TAX ID #05-410657
ON-SITE SEWAGE DISPOSAL SYSTEM
HOWARD COUNTY HEALTH DEPARTMENT
BUREAU OF ENVIRONMENTAL HEALTH

ADDRESS: 13058 Twelve Hills Road PROPERTY OWNER: Samir Hismek

RE: Capability of the new septic system at 13058 Twelve Hills Road to support 6 bedrooms

RE: File Number: F-04-091
Title: Twelve Hills, Section 3, Lots 51 & 52

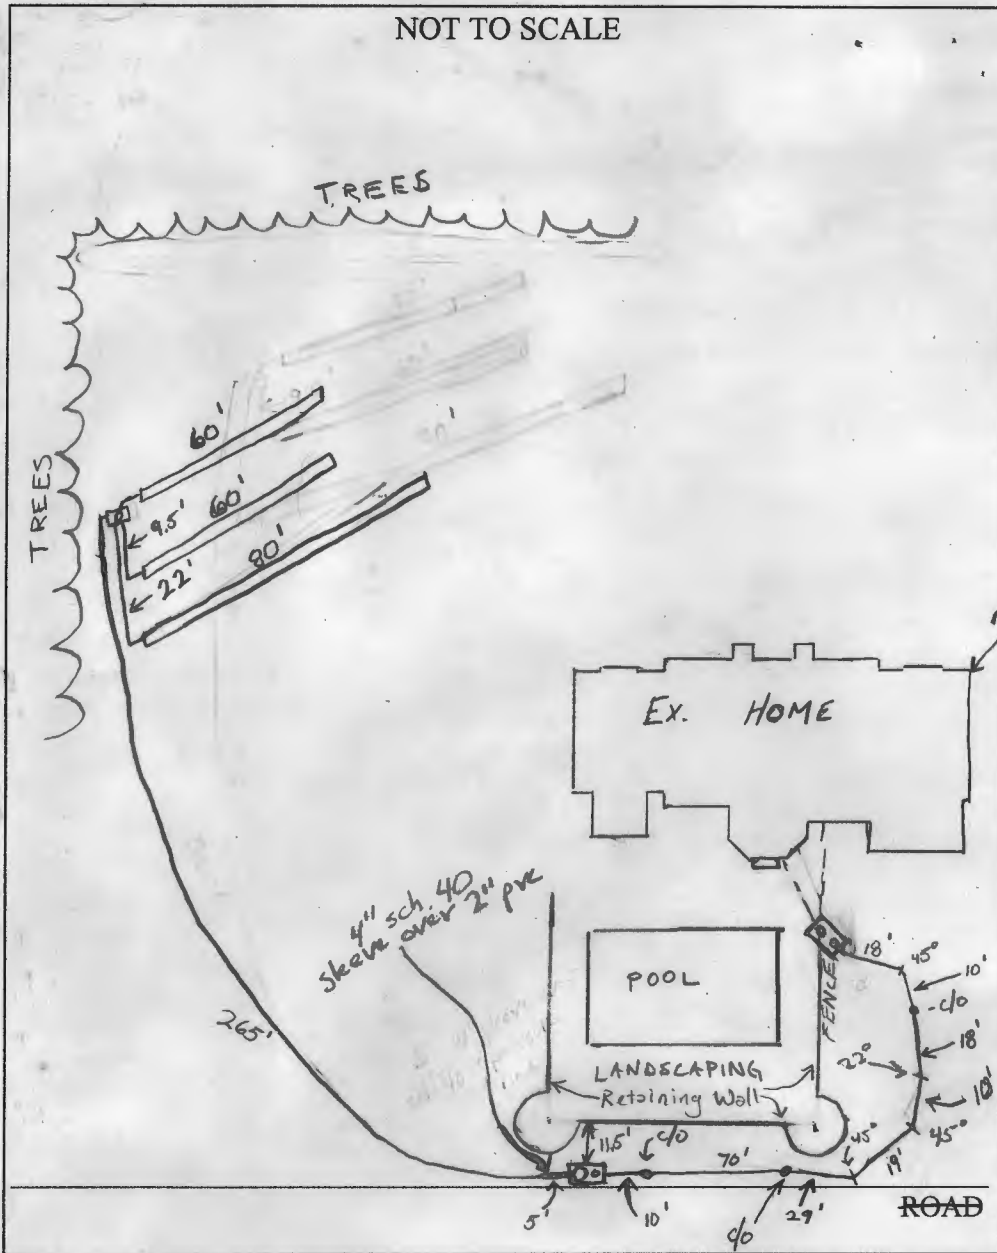
TRENCHES:	Trench to be 3.0 feet wide. Inlet 4.0 feet below original grade. Bottom maximum depth 7.0 feet below original grade. Effective area begins at 3.0 to 4.0 feet below original grade. 3.0 feet of stone below distribution pipe.
LOCATION:	Place the distribution box in the highest elevation of the approved SDA. Run two (2) 60' long trenches and one (1) 80' long trench 9' edge to edge (12' center to center), SDA must be staked prior to starting.
NOTES:	Add a cleanout between bends from existing septic tank to new pump tank. Future repair area to have shallow trenches (bottom @ 5' due to water) Repair area approx. 45' downhill of highest perc hole.

PRE-CONSTRUCTION 7/11/05 Install per permit specs → Inlet 4' bottom 7' width 3'. 2x60' and 1x80' trenches. **GAC**

INSTALLATION 7/12/05 Installation is good ok to cover all work. Need pump & Alarm for approval. **GAC**

7/22/05 Pump & Alarm test is good. Final approval granted

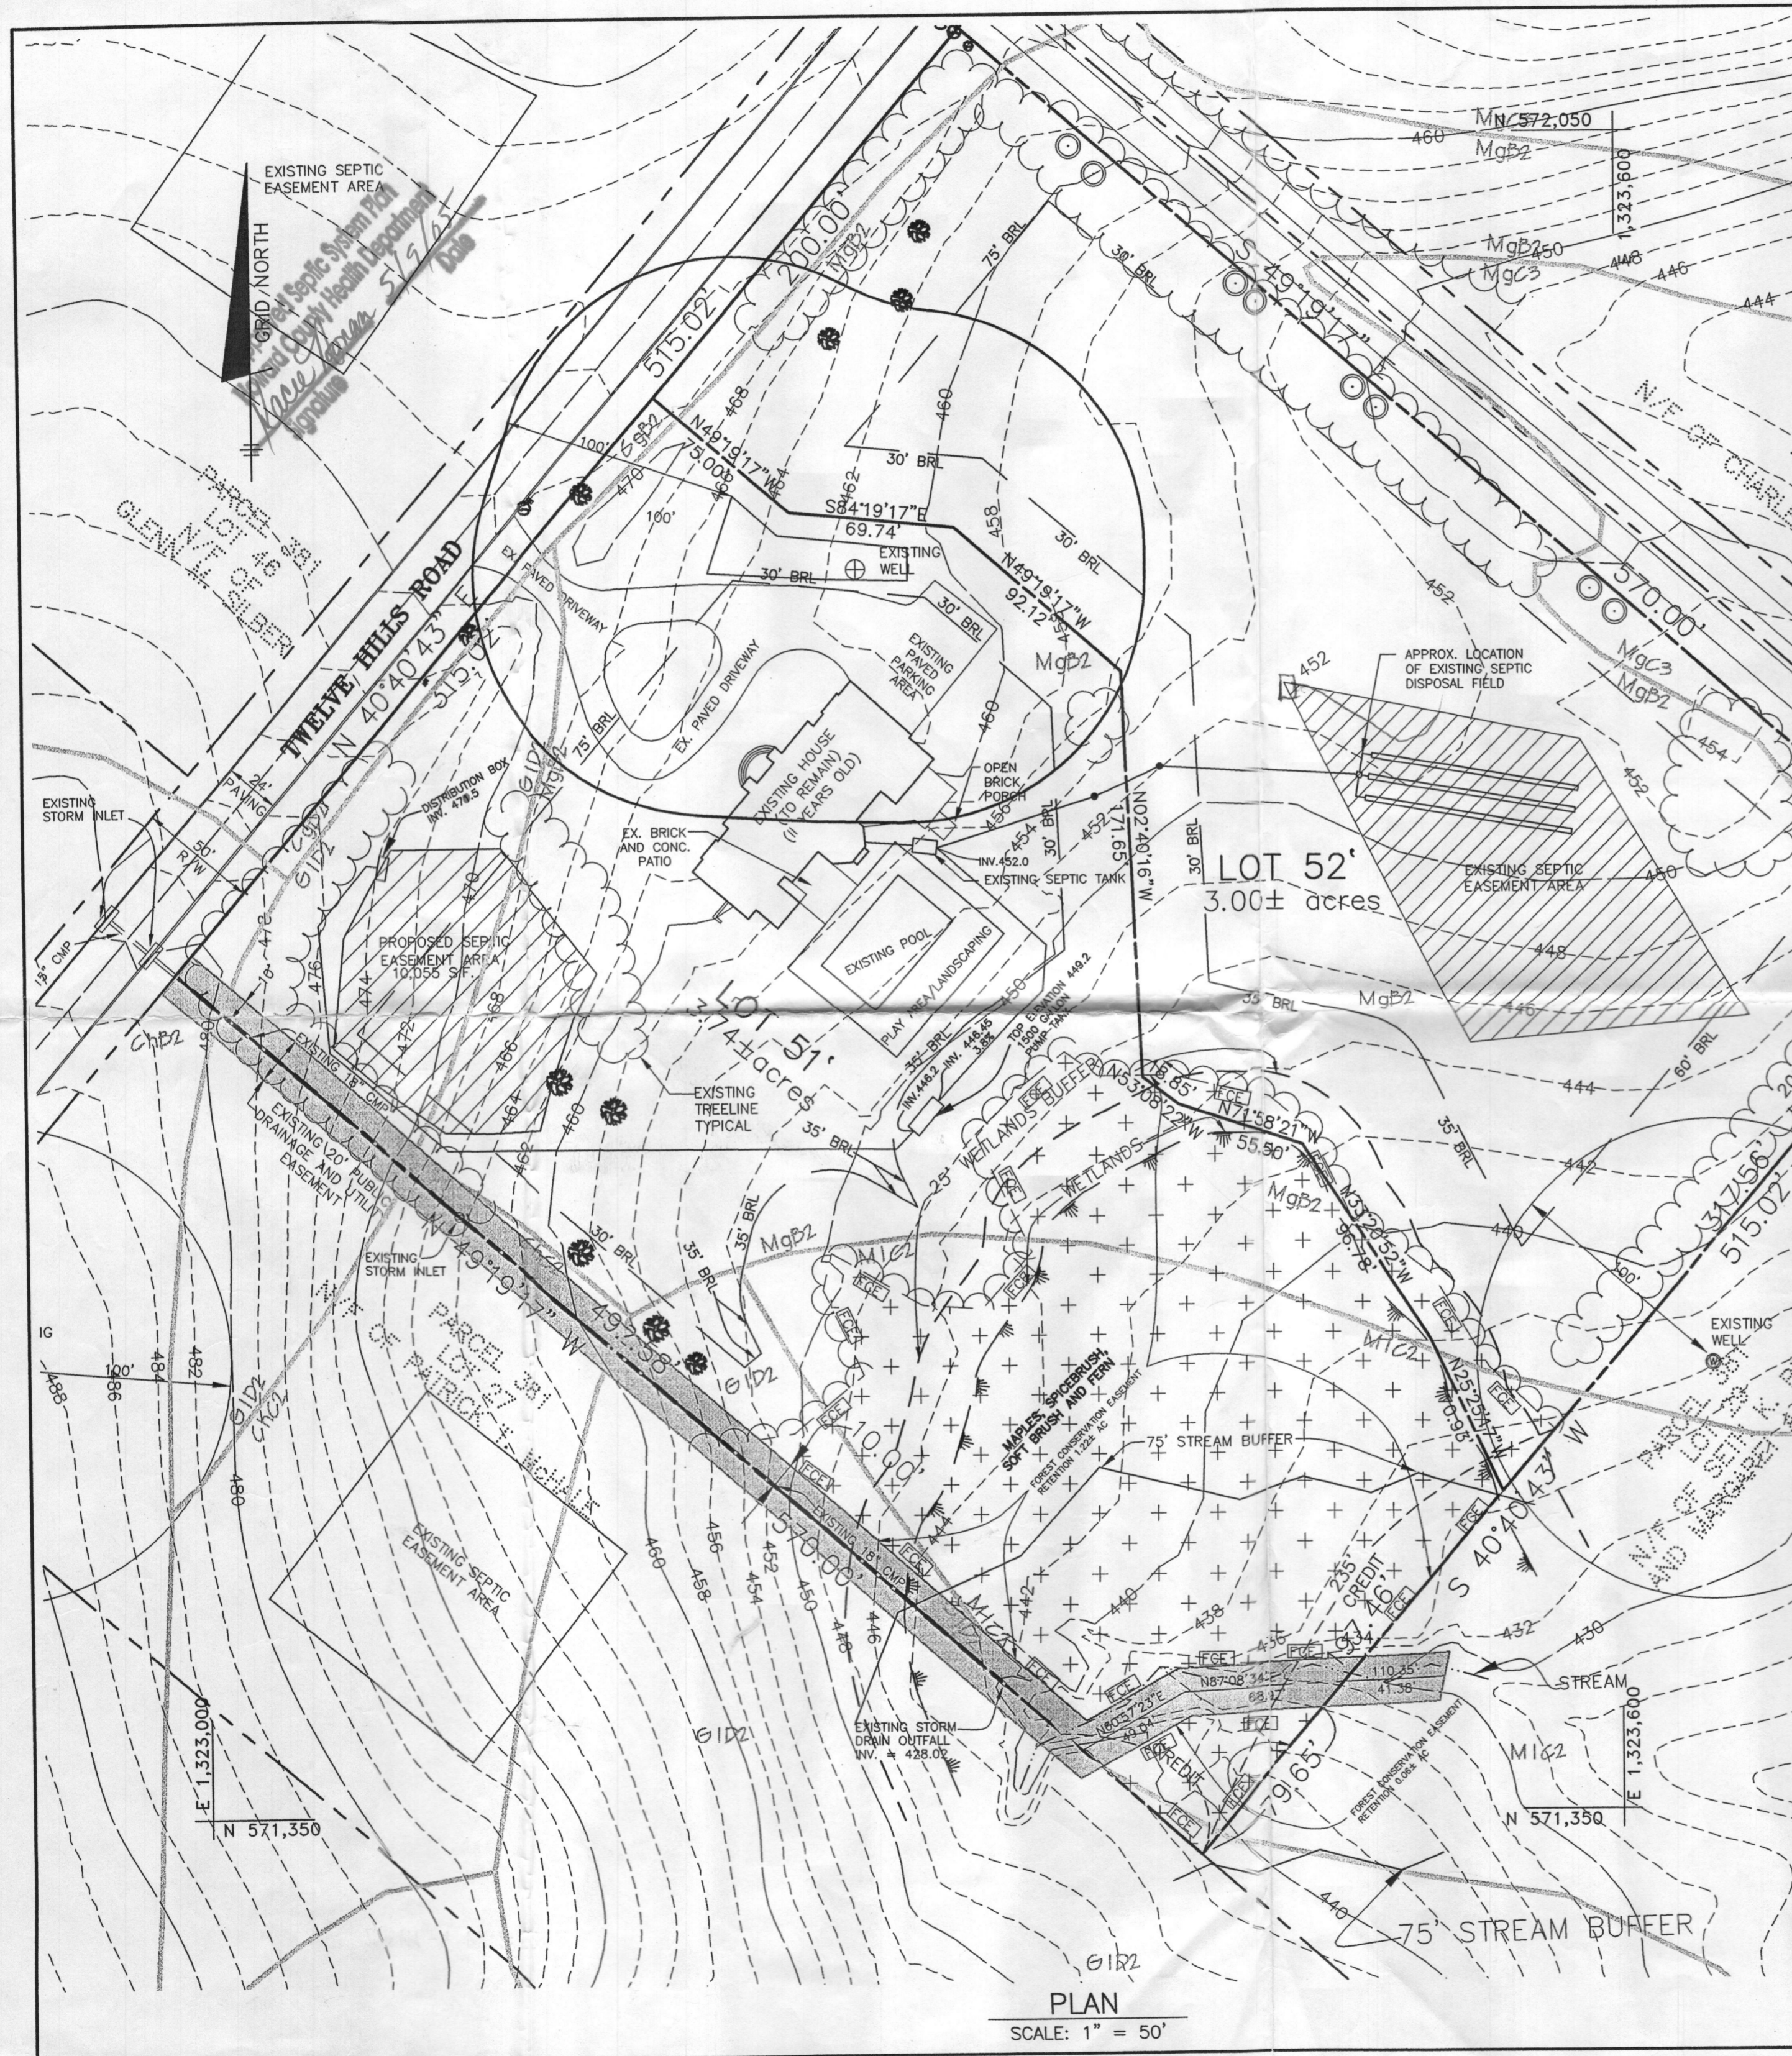
The following comment applies to the plan prepared by Benchmark Engineering, Inc. Applicant is advised to revise and resubmit with the corrections mentioned below:

- The well must be drilled and all necessary paperwork turned in prior to plan signature.

PLAN
SCALE: 1" = 50'

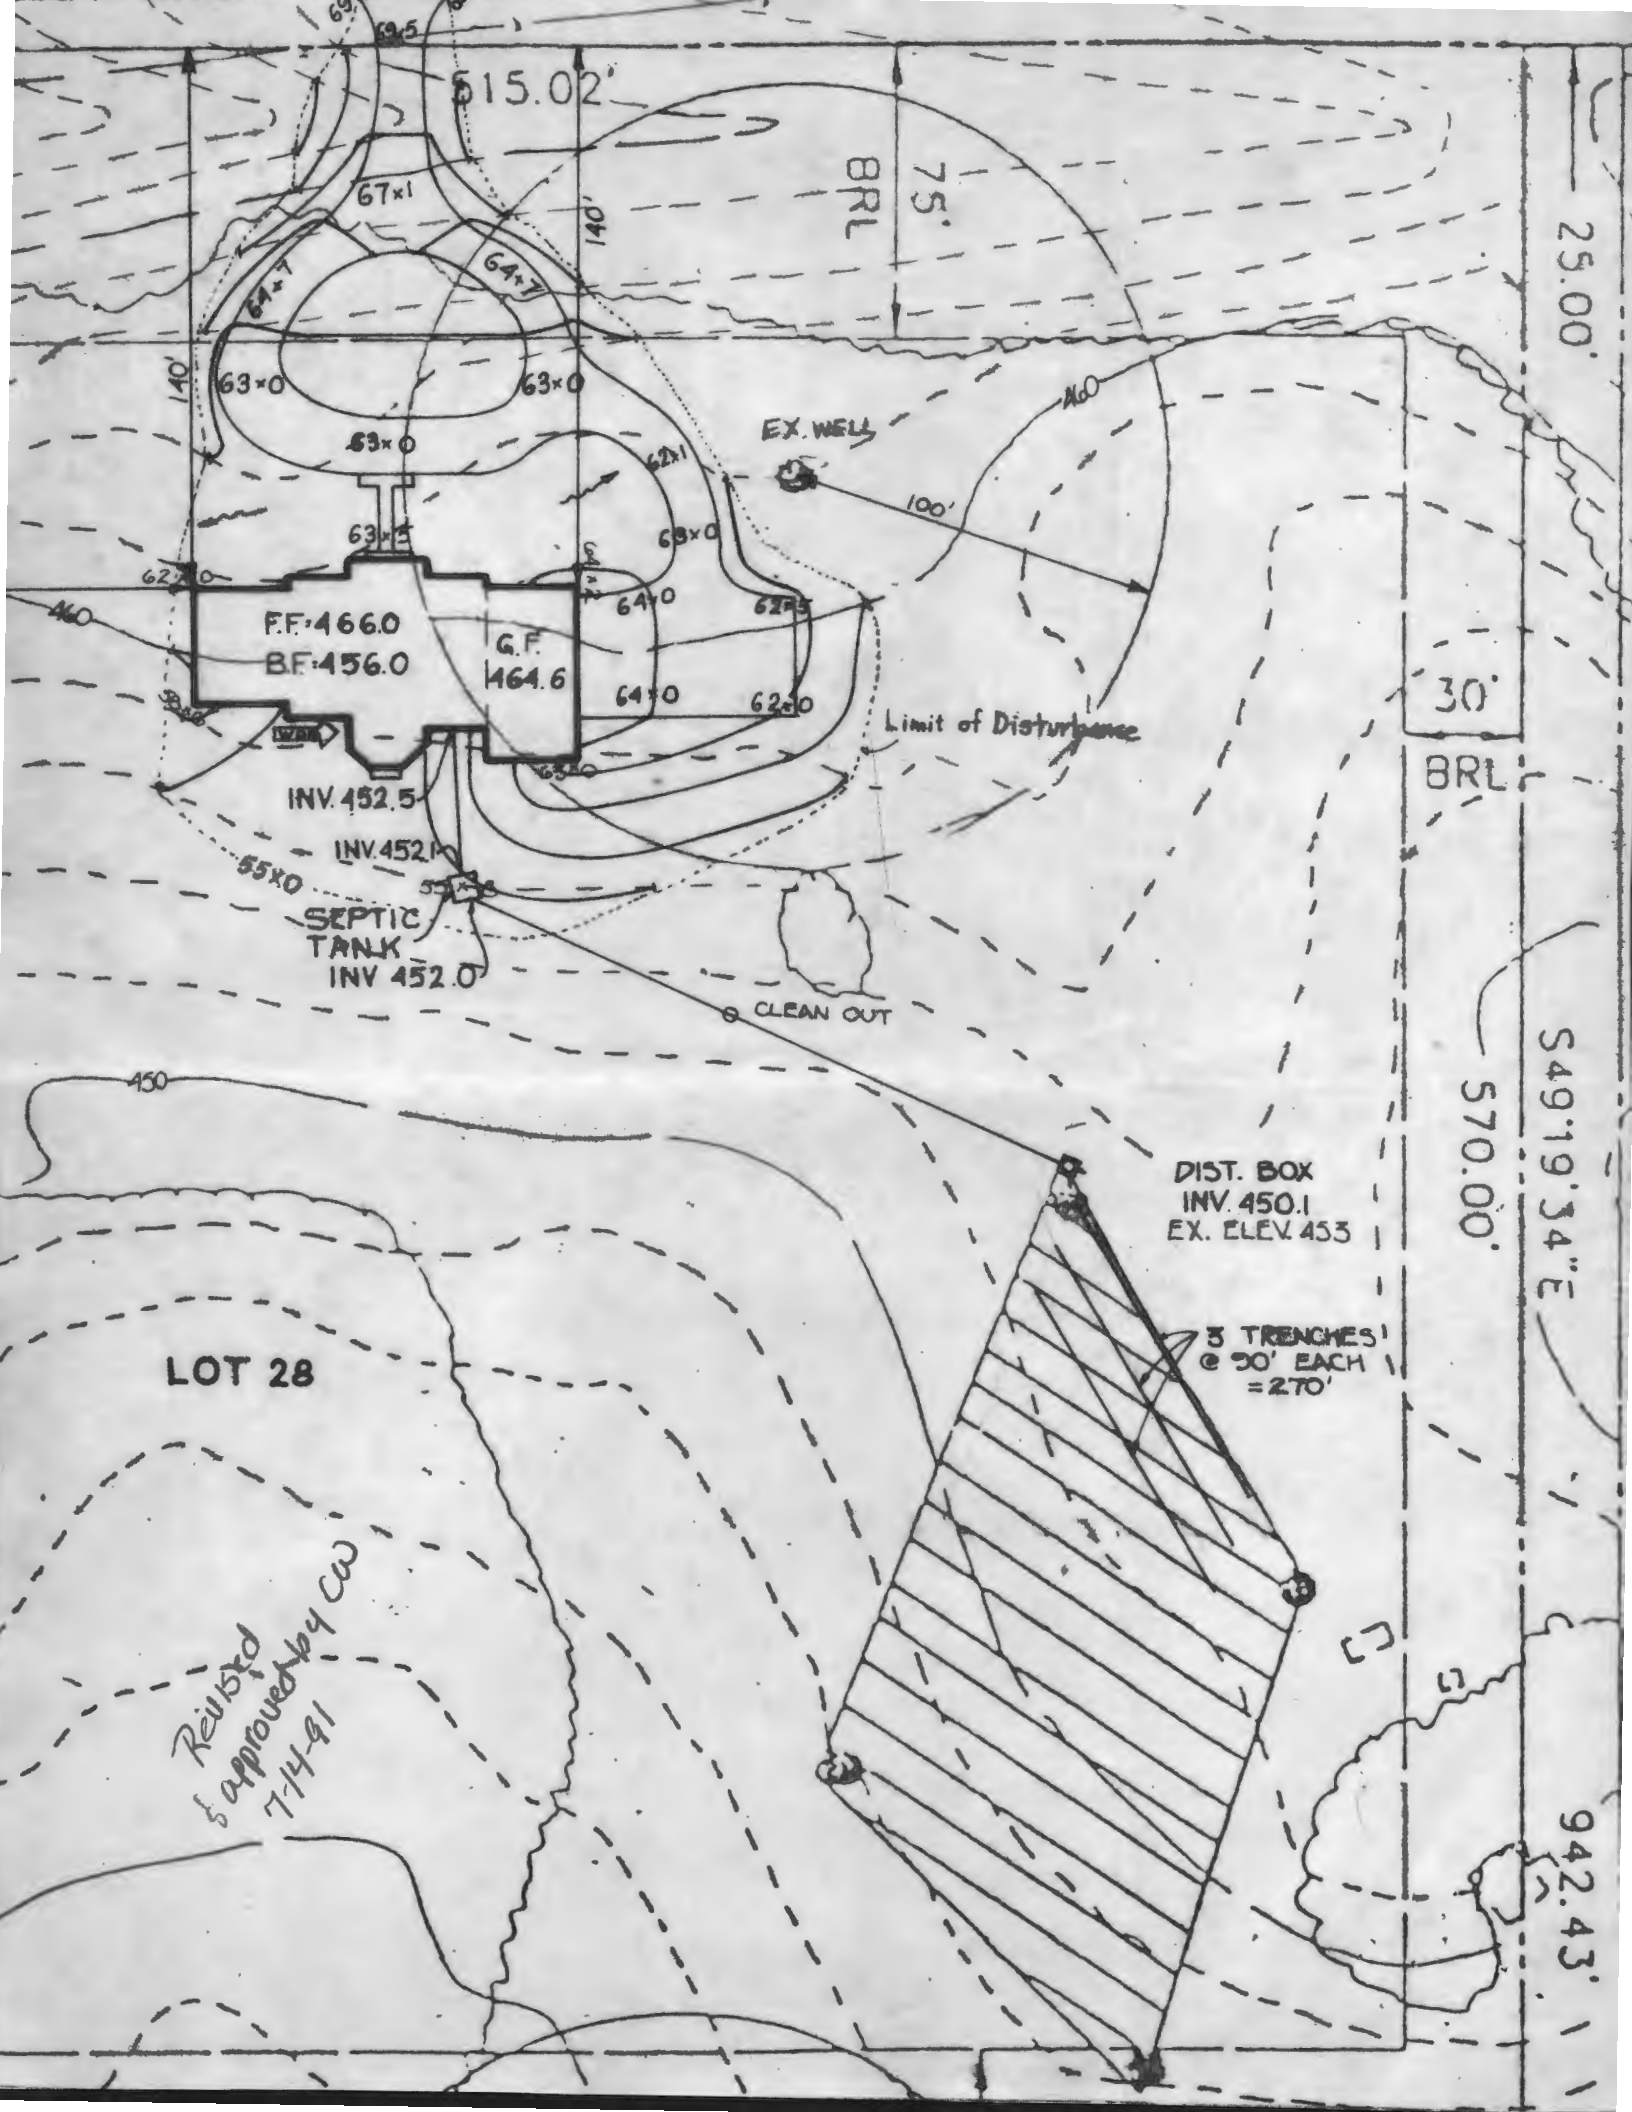
*Revised & approved by CW
7-14-91*
